## 1 Products affected

## 2 Type of change

| Product Change Notification |               |              | PCN FMAC Family - Distances of terminals |                 |     |        |             |  |

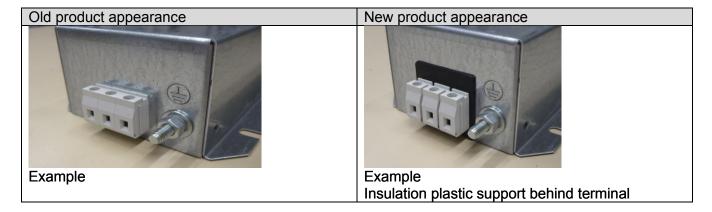
Added insulation plastic support behind terminals to increase distances.

Added insulation plastic support behind terminal to increase distances.

The dimension of the terminals increases approximately of 2mm, 1mm from each sides.

The distance between screw terminals increases approximately of 1.6mm between each other.

To increase creepage and clearance distances according to additional requirement of safety standards UL1283, CSA C22.2 No.8.
